UNITED STATES PATENT AND TRADEMARK OFFICE

APPLICATION NO.	FILING DATE	FIRST NAMED INVENTOR	ATTORNEY DOCKET NO.	CONFIRMATION NO.
10/065,091	09/17/2002	Fang-Chen Luo	5486-US-PA	4158
31561 7590 12/11/2008 JIANQ CHYUN INTELLECTUAL PROPERTY OFFICE 7 FLOOR-1, NO. 100 ROOSEVELT ROAD, SECTION 2 TAIPEI, 100 TAIWAN				
EXAMINER RUDE, TIMOTHY L				
ART UNIT		PAPER NUMBER		
2871				
NOTIFICATION DATE		DELIVERY MODE		
12/11/2008		ELECTRONIC

Office Action Summary

DETAILED ACTION

FIG. 1

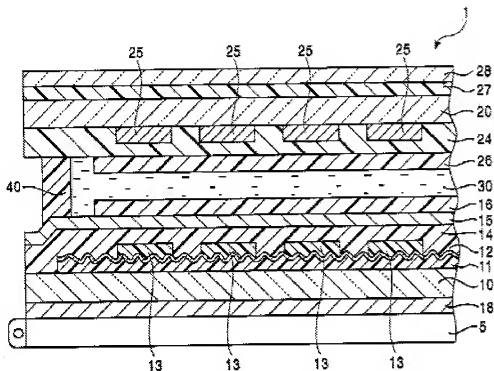
As to claims 56-58, 62, 63, 65, and 67, Tanada discloses and shows in Fig. 1, a liquid crystal display (LCD) structure comprising a first substrate panel (10) made of glass, a second substrate panel and a liquid crystal layer (30) disposed between the first substrate panel and the second substrate panel, a plurality of pixel portions being formed by respective electrodes for applying a voltage to the liquid crystal layer, each of the pixel portions comprising:

an organic insulating layer (11) such as photosensitive resin solution, such as acrylic resin (page 3, [0046]) over the first substrate panel (1), wherein the surface of the organic insulating layer has a plurality of protrude/recess structures thereon;

a conformal reflective layer (12) over the organic insulating layer (11), wherein the conformal reflective layer serves as a reflector of light;

a transparent dielectric layer (13 and 14) (color filters with their overcoat layer) over the conformal reflective layer (12), wherein the dielectric layer is a color filter layer (comprising overcoat layer) that has a substantially planar surface (smoother upper surface than the bumpy organic insulating layer); and

a first transparent conductive layer (15) conformably over the transparent dielectric layer (13 comprising 14) which is the color filter layer (comprising overcoat layer), wherein the conformal reflective layer (12) is electrically isolated from the first transparent conductive layer (15).

wherein (Fig. 1) the LCD structure further includes a second transparent conductive layer (25) over the second substrate panel (20) and the liquid crystal layer (30) between the second transparent conductive layer and the first transparent conductive layer.

Tanada does not explicitly disclose that the first conductive layer is connected to the TFT for controlling the liquid crystal layer.

As to claim 66, Tanada also shows in Fig. 1 that the surface of the second substrate panel on the opposite side of the liquid crystal layer further includes a phase compensation plate (27) and a polarizer (28).

(see planar top surfaces of 13 in Figure 1 of Tanada). In fact, all applied prior art references have planar top surfaces. It has long been well known in the art that color filters planarize (form planar top surfaces despite non-planar bottom surface); deliberate process steps are needed to *force* such surfaces to be non-planar. Examiner has considered Applicant's arguments and maintains all rejections of Applicant's present broad claim limitations are proper.

FIG. 8

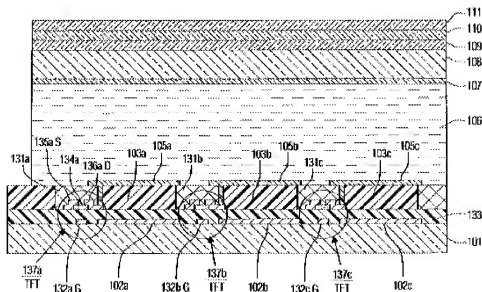
Ogawa teaches 1) a display having color filters that do not comprise an overcoat layer as an art recognized color filter suitable for the purposes of producing a color display [MPEP 2144.07], wherein the color filter layer fully covers underlying layers.

Ogawa is evidence that workers of ordinary skill in the art would find the reason, suggestion, or motivation to add color filters that do not comprise an overcoat layer as an art recognized color filter suitable for the purposes of producing a color display [MPEP 2144.07]. Please note that this proves the overcoat layer of Tanada was known to be NOT essential to such a reflective color filter display, which makes it obvious that the overcoat layer is optional.

Therefore, it would have been obvious to one having ordinary skill in the art at the time the invention was made to modify the invention of Tanada with color filters that do not comprise an overcoat layer and fully cover underlying layers as an art recognized color filter suitable for the purposes of producing a color display [MPEP 2144.07].

(2) It is respectfully pointed out that the color filter layer of Ogawa is contiguous (though multi-colored, as is Applicant's layer) and it does fully cover all underlying layers, including the conformal reflective layer(s).
